**Addendum No. 2**  
**November 27, 2024**

**Project: SIOUX FALLS CAREER & TECHNICAL EDUCATION ACADEMY'S AGRICULTURE  
& CARPENTRY ADDITION PROJECT PD #3471**

Architect: Architecture Incorporated

DOOR DETAILS & BORROWED LITE SCHEDULE & DETAILS

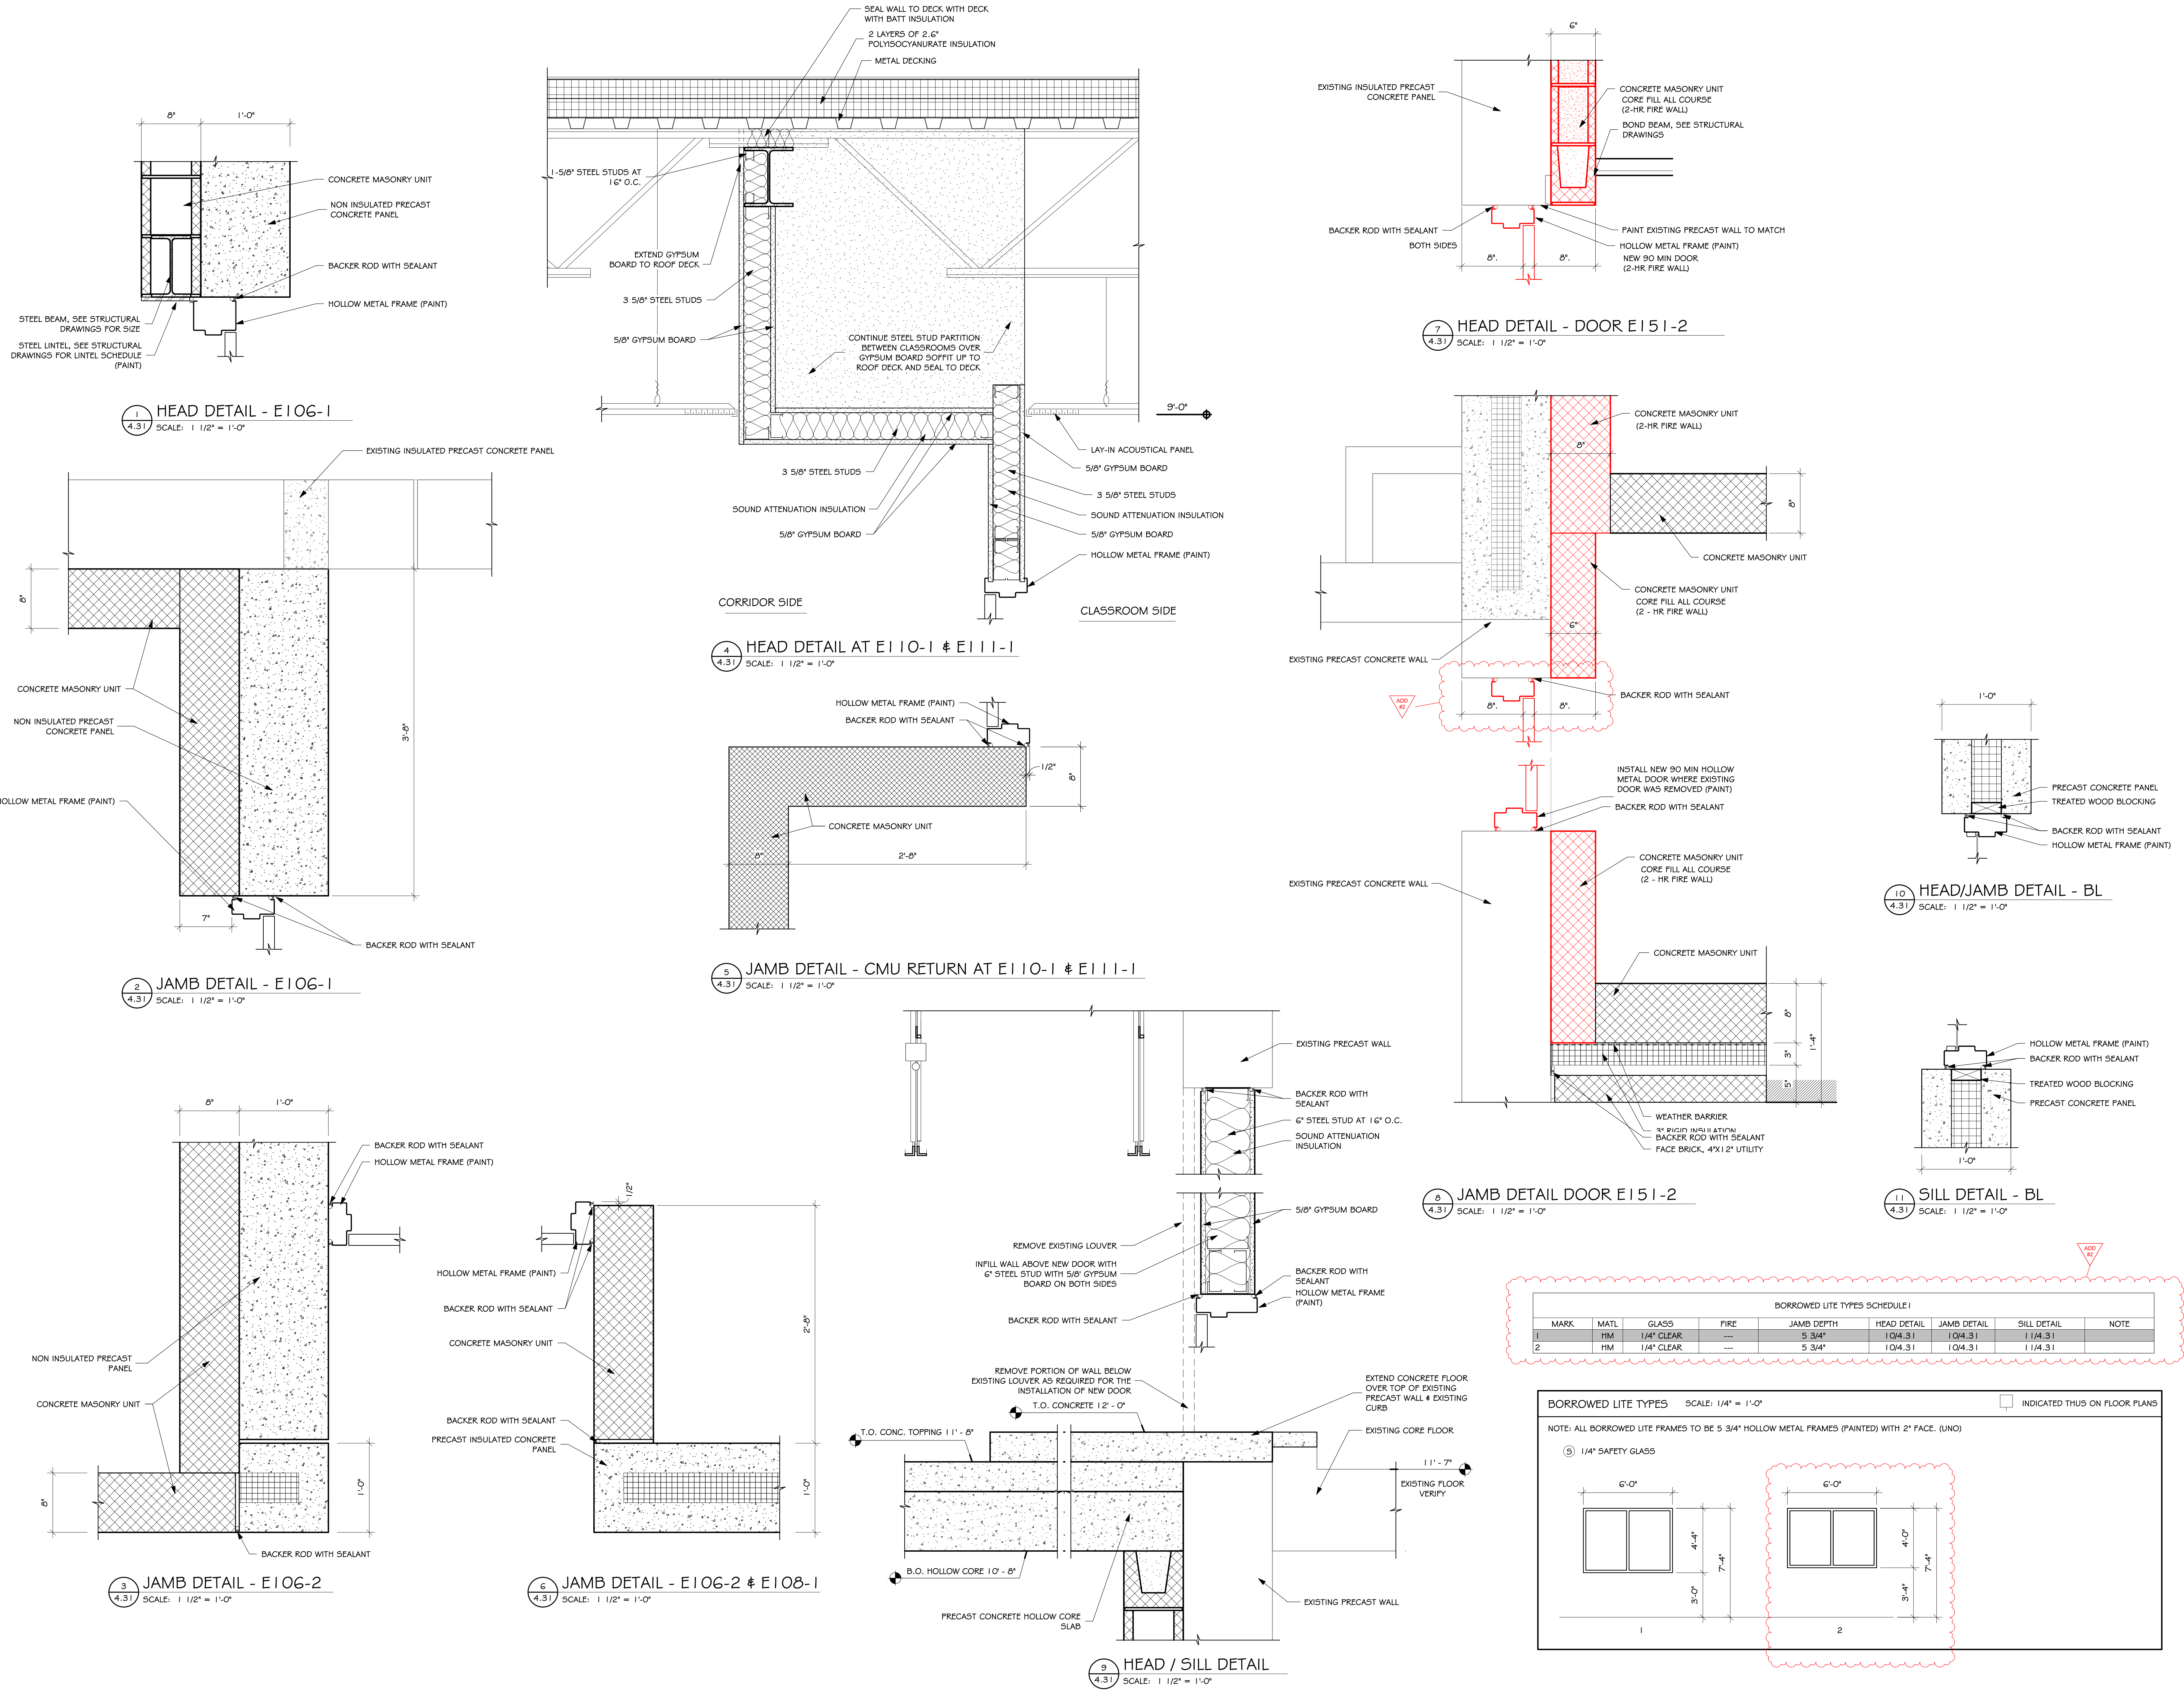
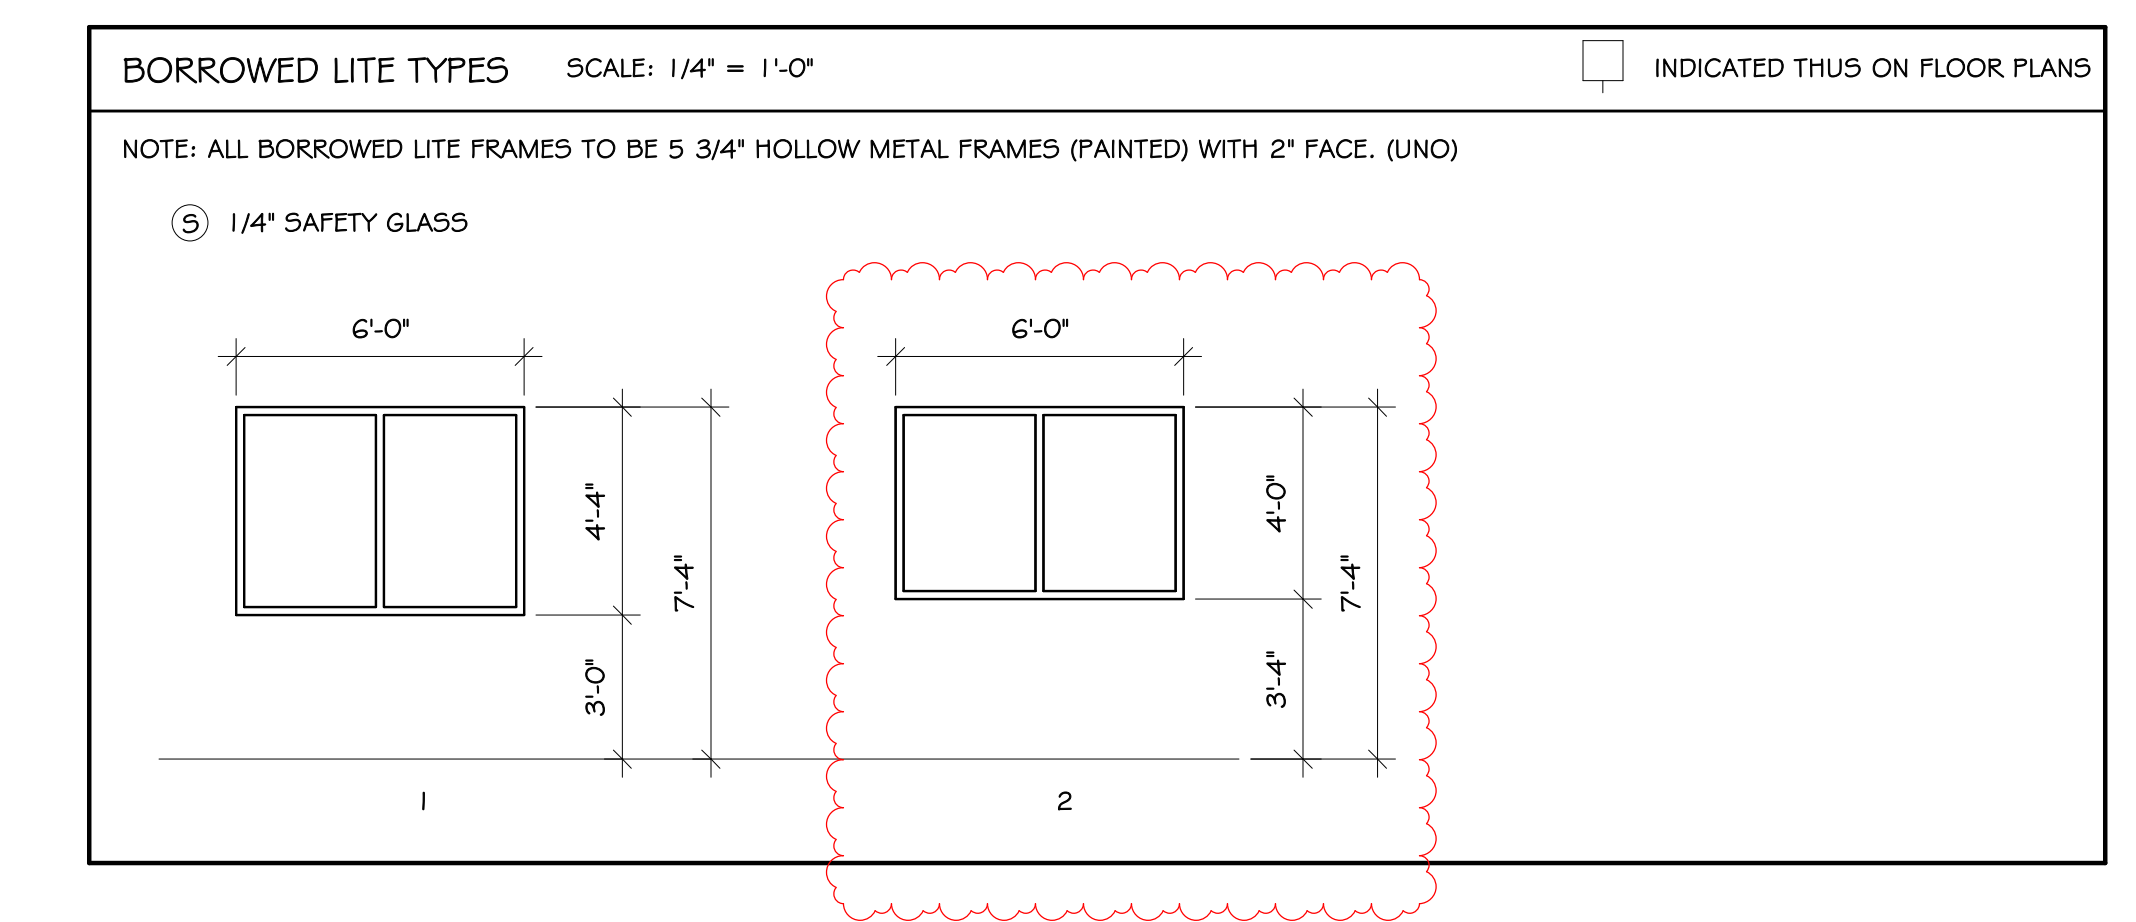
- a) Borrowed lite Type 2 has been added to the *Borrowed Lite Types Schedule*.
  - i) The Type 1 borrowed lite that occurs in the precast wall between Barn E108 and Animal Science E100 (south of door E108-4) shall be changed to a Type 2 borrowed lite.
  - ii) Reference (attached) *revised* drawing Sheet 4.31, revision dated 11-27-24, attached to the end of this addendum for additional information.
